File #: LN-525

DEVELOPMENT REVIEW COMMITTEE
Meeting Date: DECEMBER 4, 2024

NEW TURN LANE & ENTRY

Request: Minor Site Plan
P&Z# 23-12000032
Owner: Oldcastle APG South Inc
Project Location: 1200 NW 18th Street
Folio Number: 484227480010
Land Use Designation: I (Industrial)
Zoning District: I-1 (General Industrial)
Commission District: 4 (Beverly Perkins)
Agent: John Tice (jtice@galloherbert.com)
Project Planner: Diego Guevara (954-786-4310 / diego.guevara@copbfl.com)

AS-1.1

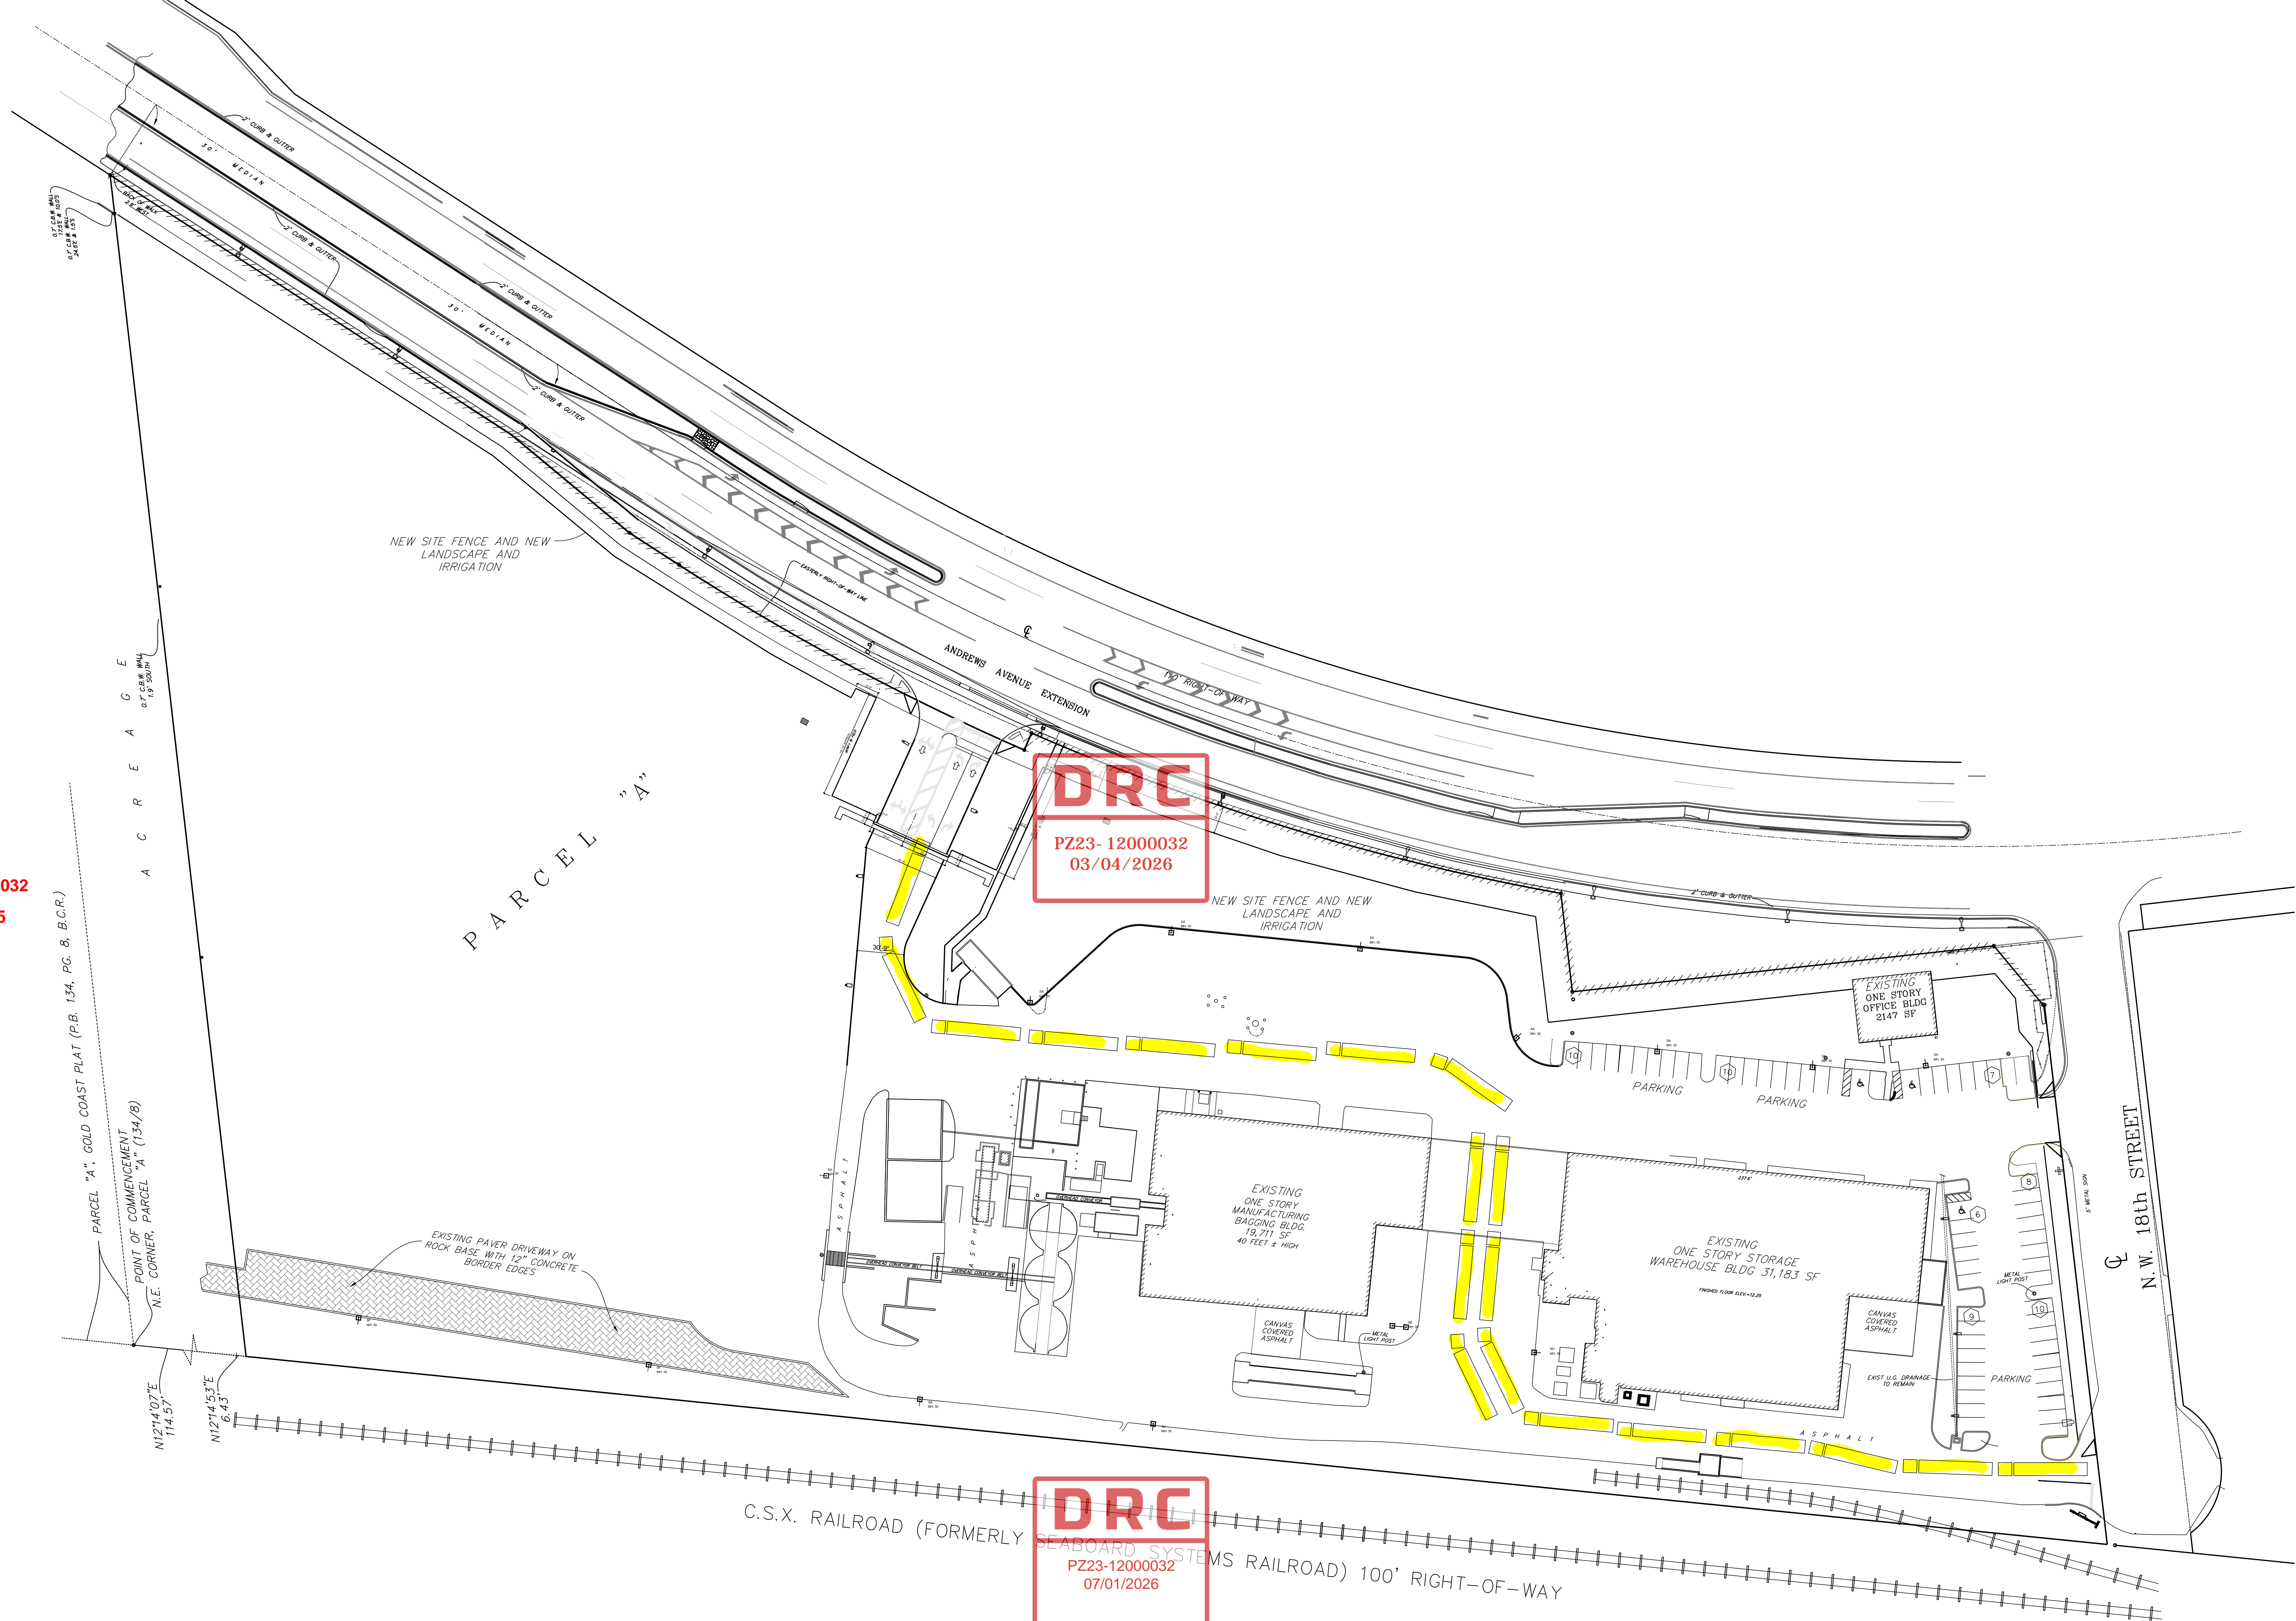
3. Connect the proposed driveway with the properties. It seems to be "floating". Provide the width dimension of it. A two-way driveway must be at least 24 feet wide. The minimum width must be maintained along all the length of the driveway

4. Add dimension showing the width at the narrowest point at the proposed entry. During the previous DRC meetings, the applicant aggrieved to add the note, however it has not been added to the plans.

5. Add dimension line showing the width at the narrowest point (goose neck) at the proposed entry.

RESPONSE: The existing Paver driveway is show exactly as it is shown on the survey. There is a gap between the asphalt driveway and the paver driveway. This can be asphalted to "connect" them if this is a requirement. The existing paver driveway is 32 feet wide for the majority of it and it does reduce down to 18 feet at the north end and 19 feet at the south end. This Driveway is not required to be two way so we would leave it as is which is an 18 foot wide, overflow connector with a bypass lane.

RESPONSE: A dimension was added at the narrowest point of the new entry driveway. It is 30 feet 9 inches at this point.

RESPONSE: The dimension has been added to sheet AS 1.1. Site Plan.

DRAWN	
CHECKED	
DATE	08/16
SCALE	1/2" = 1'-0"
JOB NO.	16-0-15
SHEET	201

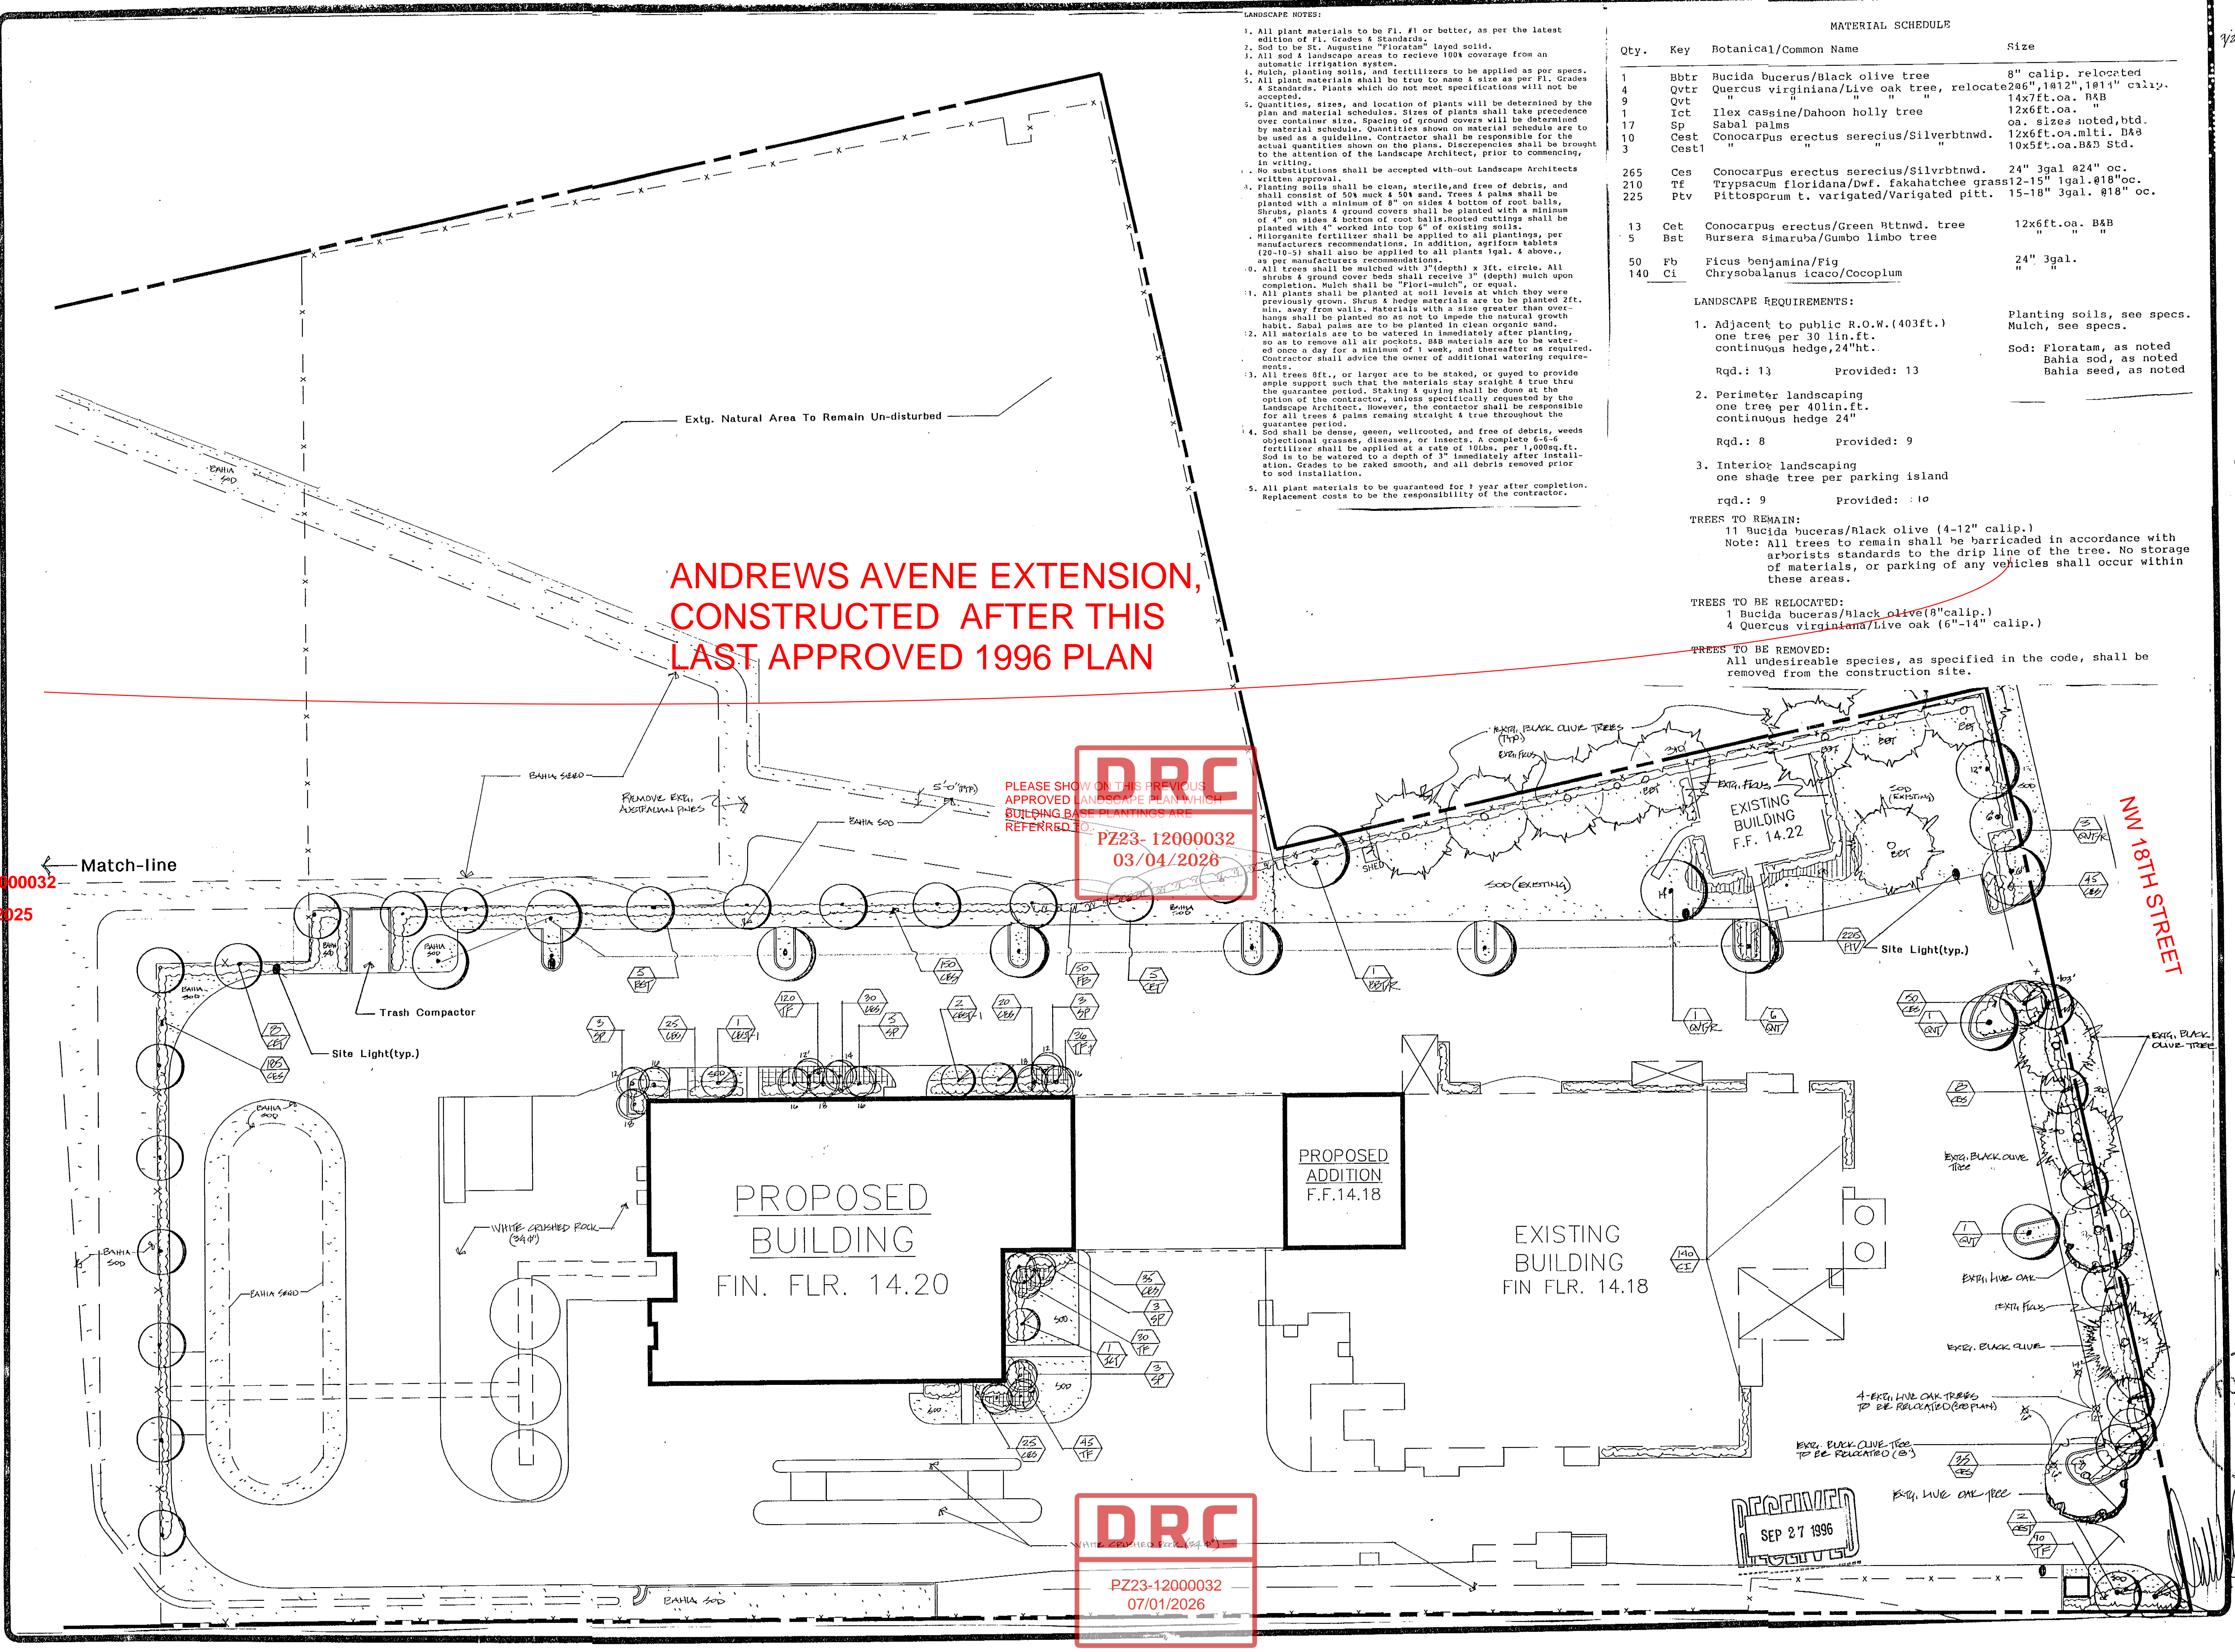
6. Provide the required Building Base planting along the building facades that face the streets.

1. Include originally approved plan showing the foundation planting at time of permit submittal and note as such on the Landscape Plan(s). New plan shall include the foundation plantings along the building on both sides as per the original approved plan of record.

DRC
PLEASE SHOW ON THIS PREVIOUS APPROVED LANDSCAPE PLAN WHICH BUILDING BASE PLANTINGS ARE REFERRED TO.
PZ23-12000032
03/04/2026

RESPONSE: Urban Forester note 1 states to show foundation planting at time of permit submittal and note on Landscape Plan and shall include the foundation plantings along the building on both sides as per the original approved plan of record.
